Reference: 300001(6) BMY/LF

7 November 2025

## Ivanhoe Estate Stage 2 Development Application Stormwater and Drainage Assessment Addendum – Building C4

ADW Johnson was previously engaged by Frasers property Australia (FPA), to undertake a Stormwater and Drainage Assessment to accompany a State Significant Development Application (SSDA) for Stage 2 of the Ivanhoe Estate redevelopment.

drawing title:  
**AMENDED C4 CATCHMENTS**

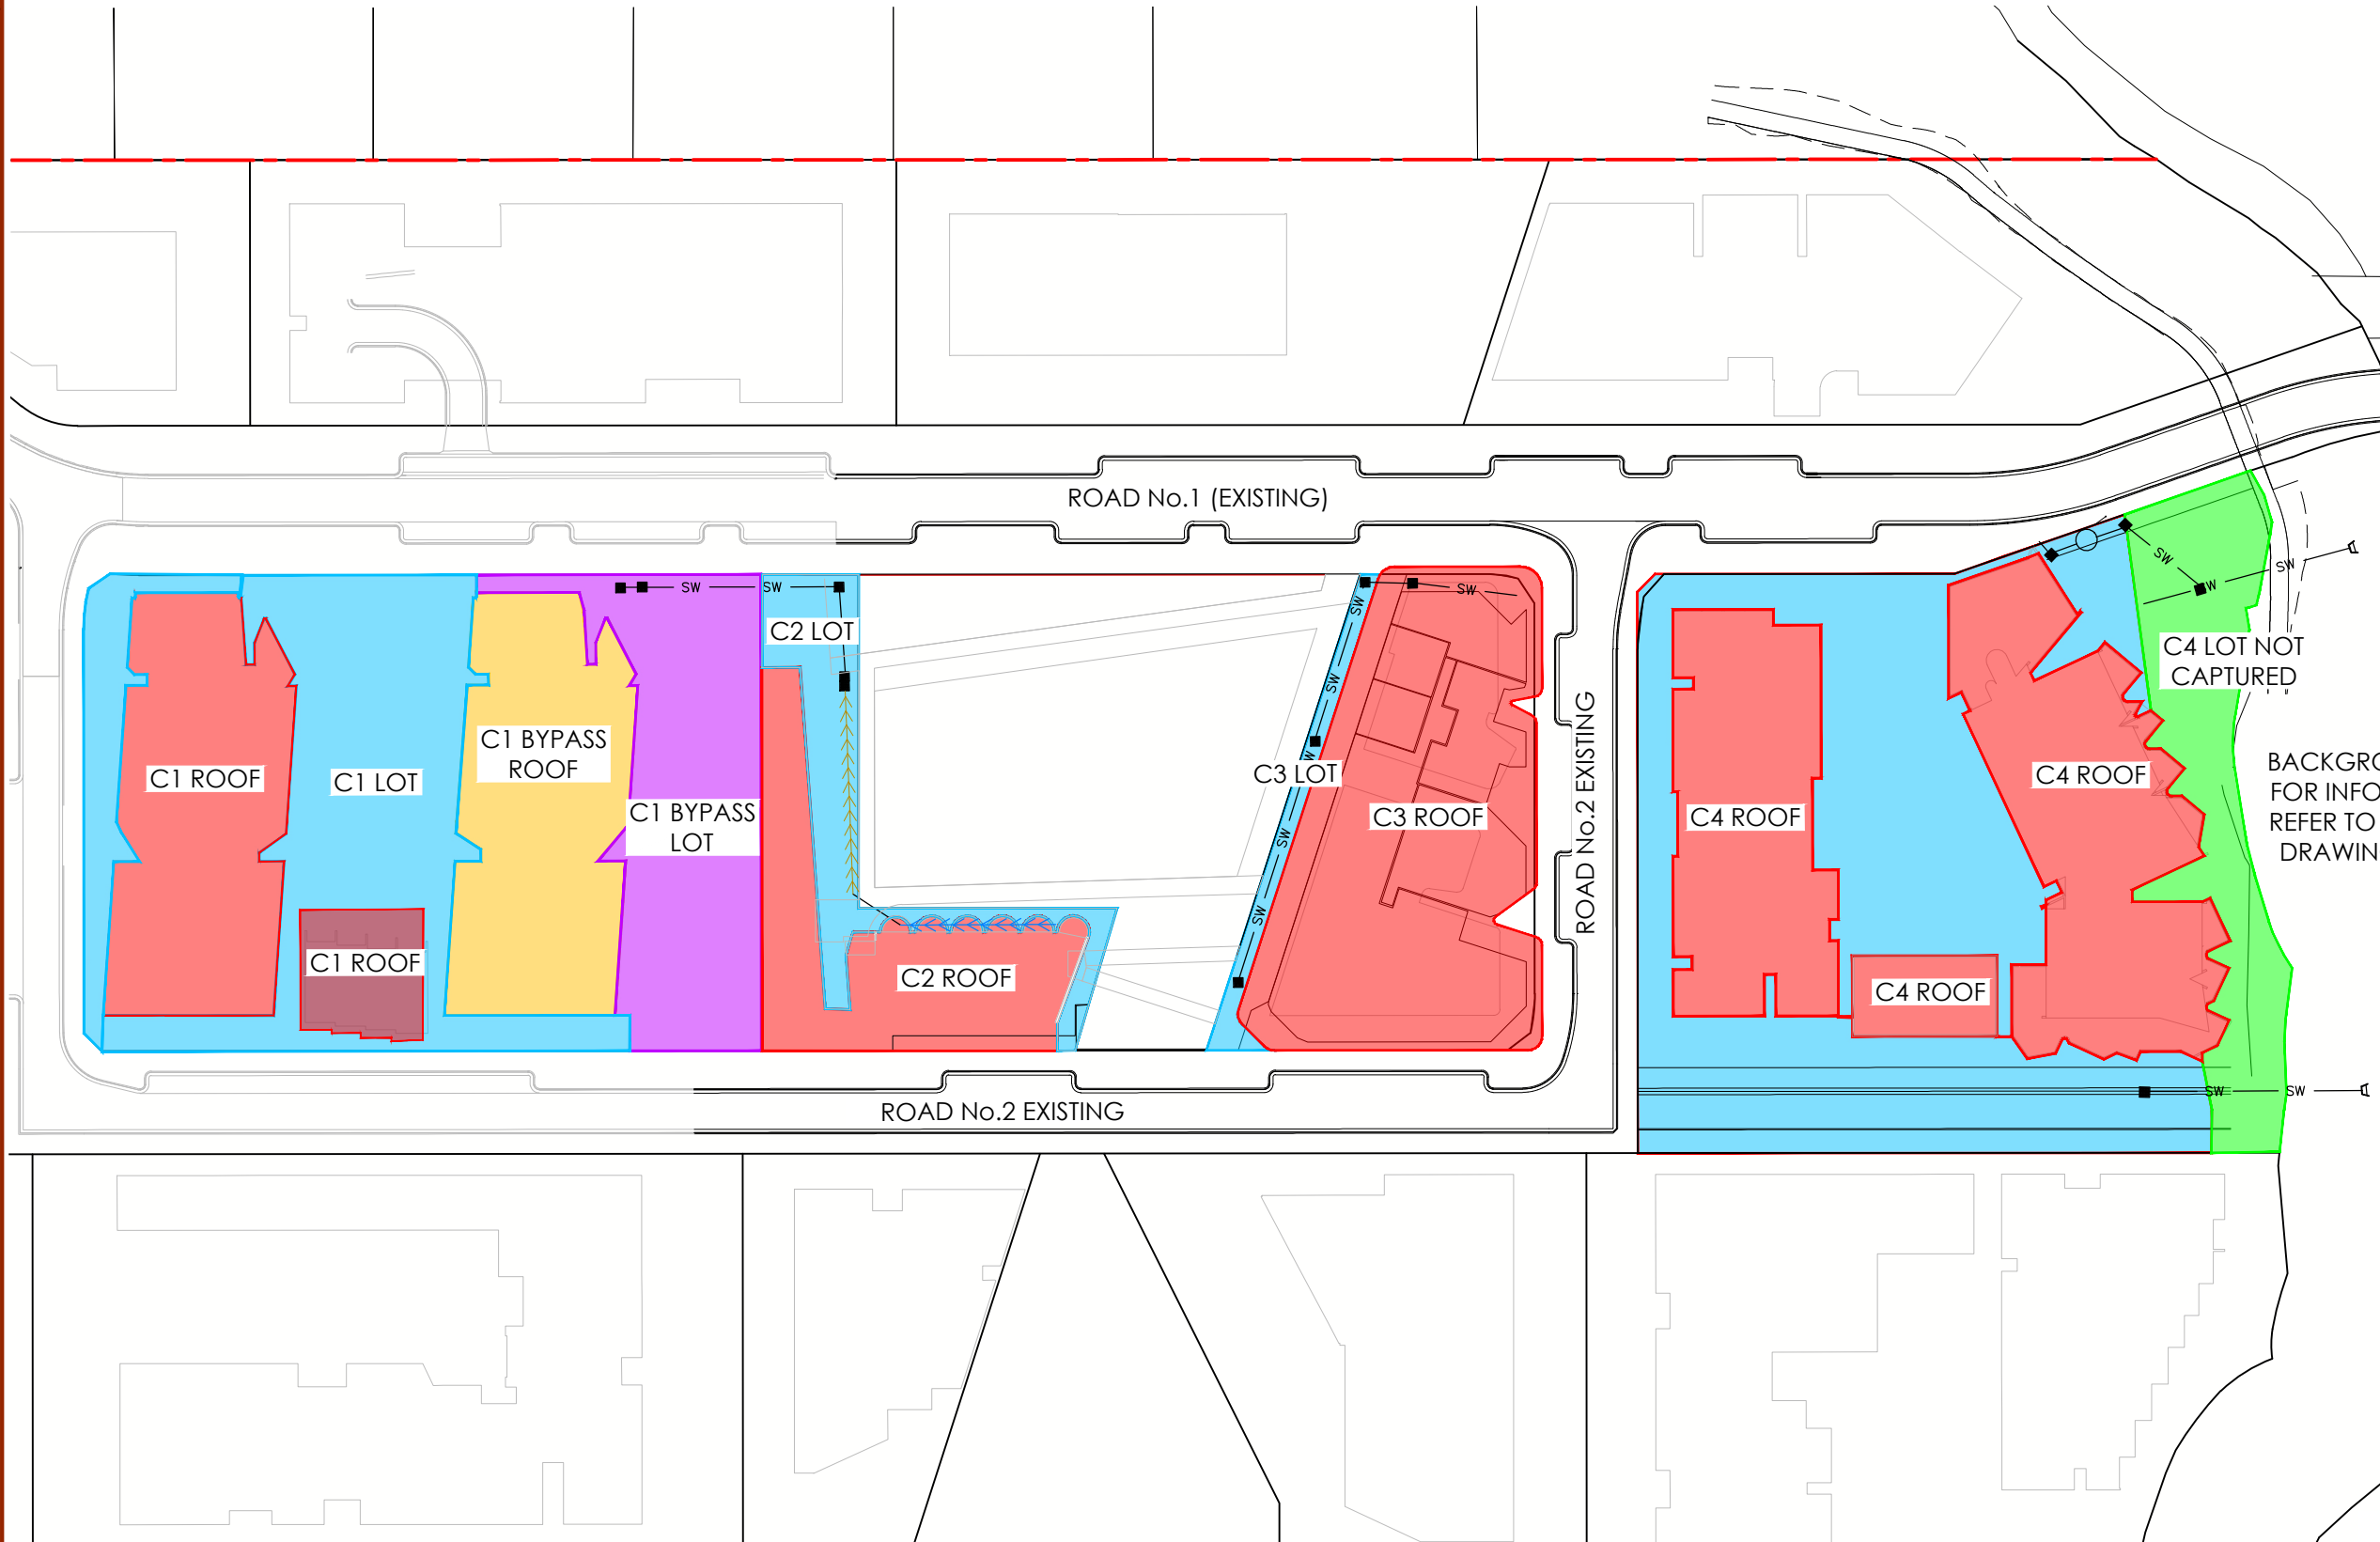
- Amended basement footprint following reduction of number of basement levels
- Amended open space / landscape layouts

The abovementioned changes will have an impact on the proposed stormwater catchments and hence the stormwater controls outlined within the approved stormwater management plan and therefore updated modelling is required to ensure compliance with Council's requirements.

In accordance with the approved report, to ensure the runoff generated by the C4 site is accurately calculated the lot has been split into three (3) sub catchments being roof, remaining lot captured and remaining lot not captured.

The amended sub catchment areas can be seen in **Appendix B** and **Table 1** below.

CATCHMENT AREA (ha)			
Catchment	Roof	Remaining Lot (Captured)	Remaining Lot (Not Captured)
C4 - Original	0.301	0.338	0.111
C4 - Updated	0.308	0.327	0.115

Catchment	5 Year ARI Flow (m3/s)	100 Year ARI Flow - Without Detention (m3/s)	100 Year ARI Flow - With Detention (m3/s)	Rain Water Tank Size (kL) <sup>#</sup>	Detention Storage (m³)
C4 - Original	0.25	0.42	0.25	20	135
C4 – Updated	0.25	0.42	0.25	20	143.25

It can be seen from **Table 2** that the proposed changes to the C4 site have resulted in similar peak flows, however due to less height available within the tank, the overall storage volume has been increased.
